Form 3160-5  
(June 2019)UNITED STATES  
DEPARTMENT OF THE INTERIOR  
BUREAU OF LAND MANAGEMENTFORM APPROVED  
OMB No. 1004-0137  
Expires: October 31, 2021**SUNDRY NOTICES AND REPORTS ON WELLS**  
**Do not use this form for proposals to drill or to re-enter an abandoned well. Use Form 3160-3 (APD) for such proposals.**

8. Well Name and No. HAWK 35 FED/401H

9. API Well No. 3002548030

EOG respectfully requests an amendment to our approved APD for this well to reflect the following changes:

## WELL LOCATION AND ACREAGE DEDICATION PLAT

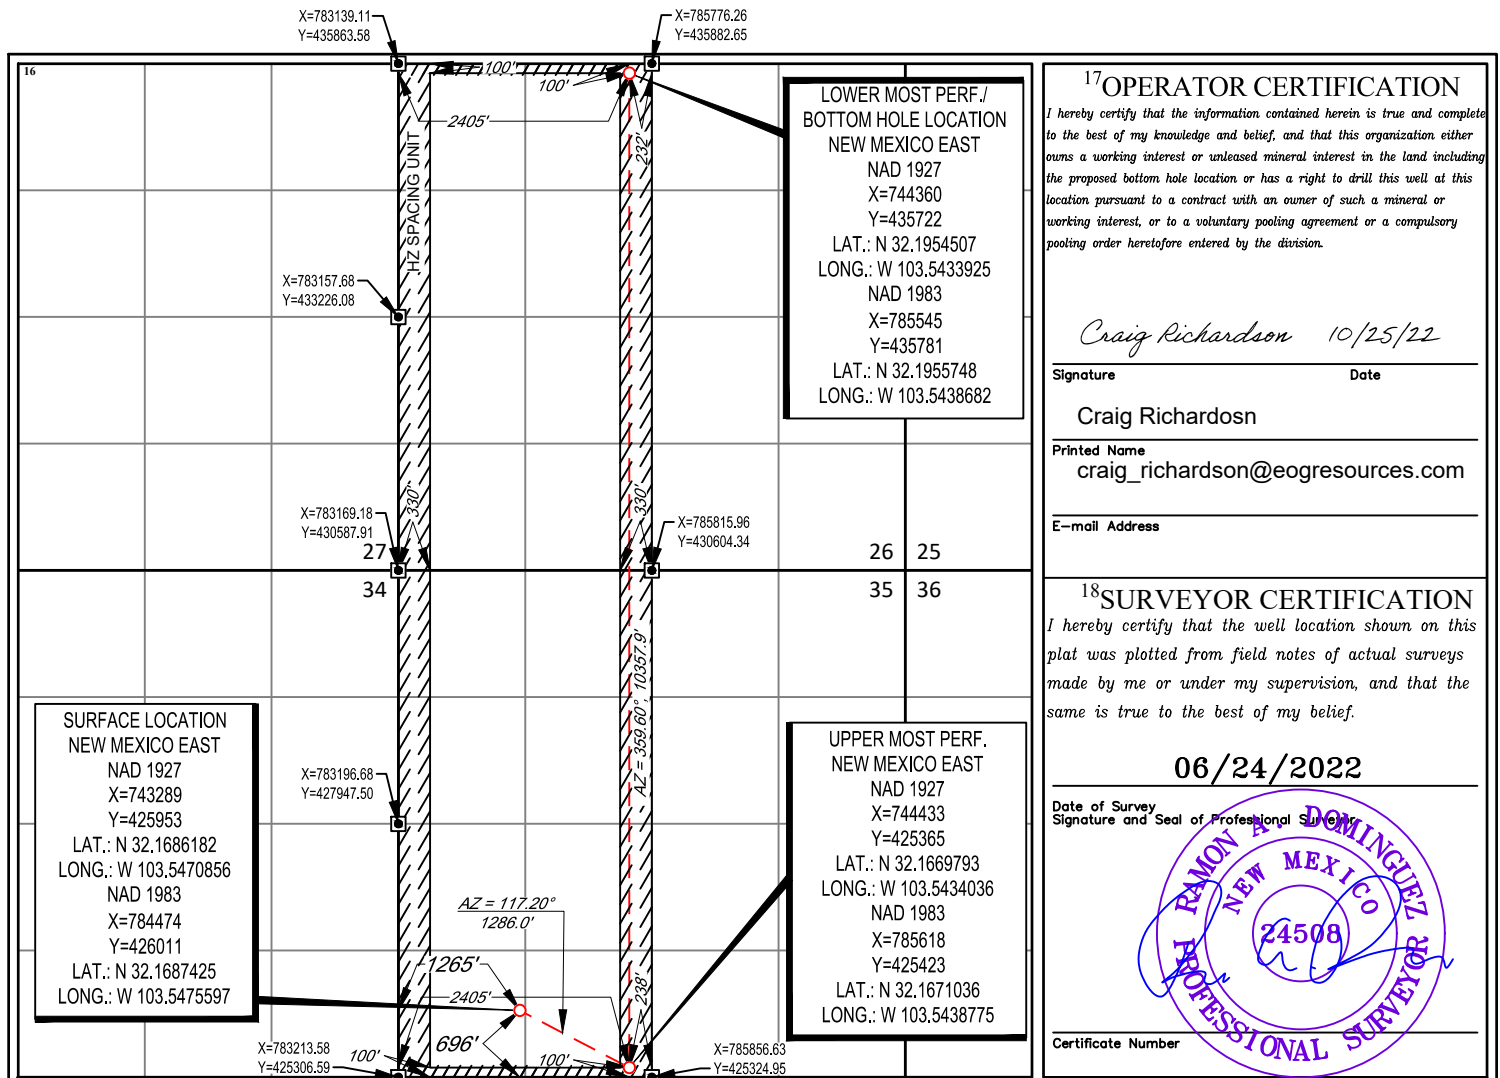
Change BHL from T-24-S, R-33-E, Sec 26, 100' FNL, 660' FWL, Lea Co., NM, to T-24-S, R-33-E, Sec 26, 100' FNL, 2405' FWL, Lea Co., N.M.

| UL or lot no. | Section   | Township    | Range       | Lot Idn  | Feet from the | North/South line | Feet from the | East/West line | County     |
|---------------|-----------|-------------|-------------|----------|---------------|------------------|---------------|----------------|------------|
| <b>C</b>      | <b>26</b> | <b>24-S</b> | <b>33-E</b> | <b>-</b> | <b>100'</b>   | <b>NORTH</b>     | <b>2405'</b>  | <b>WEST</b>    | <b>LEA</b> |
